ChemLogic® CL1 Legacy Pump Conversion

DOD Technologies routinely evaluates our gas detection systems, providing updates and improvements with the latest technological advancements. As of Fall 2024, we have tested and approved a new diaphragm pump to replace a discontinued model.

DOD P/N: 870328

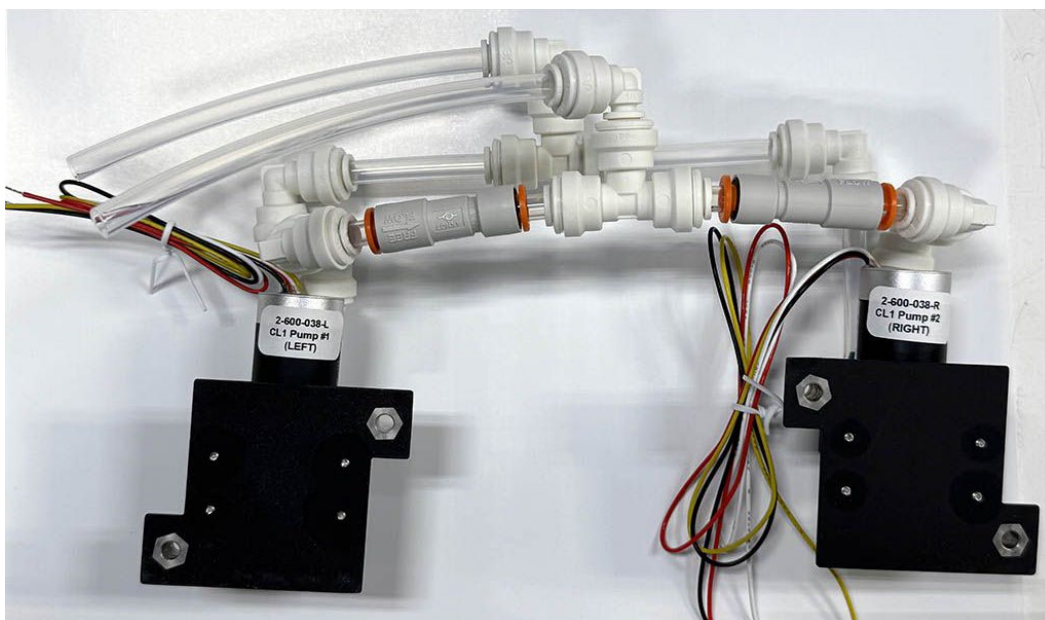
CL1 monitors have been manufactured with the same (Brailsford) model pump since the product's inception. This part is no longer in production and out of inventory.

If a CL1 is set up to accept the discontinued pumps, it will need to be converted to accept the new replacement pumps. The first step to converting involves evaluation and updates to the system's firmware and software. See the requirements on the chart below. Once updated and converted, the newer style pumps (Pump 1-Left and Pump 2-Right) can be replaced as needed moving forward. Conversion kit ordering information is as follows:

Description: Replacement Pump Assembly – 2025 Version (For New or Converted CL1 Units), Includes Left and Right Side Pumps

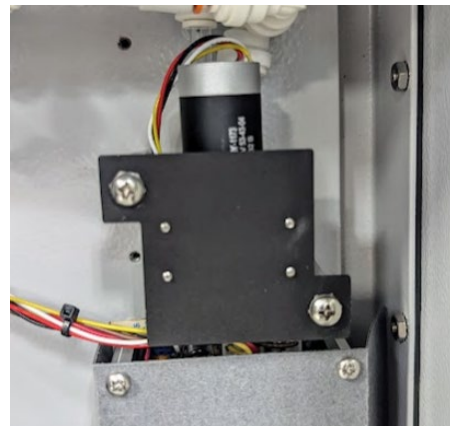
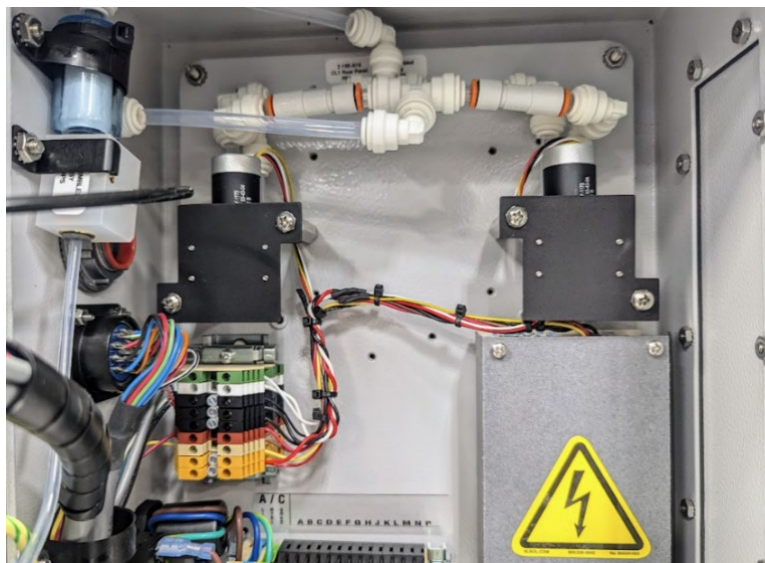
Existing CL1 units must complete the one-time conversion before utilizing the newer replacement pumps on an ongoing basis. The conversion process will allow the units to accept the Left and Right side replacement pumps, as shown below. When ordering future replacements, the assembly noted below will include both Left and Right pumps. The pumps are only available as an assembly.
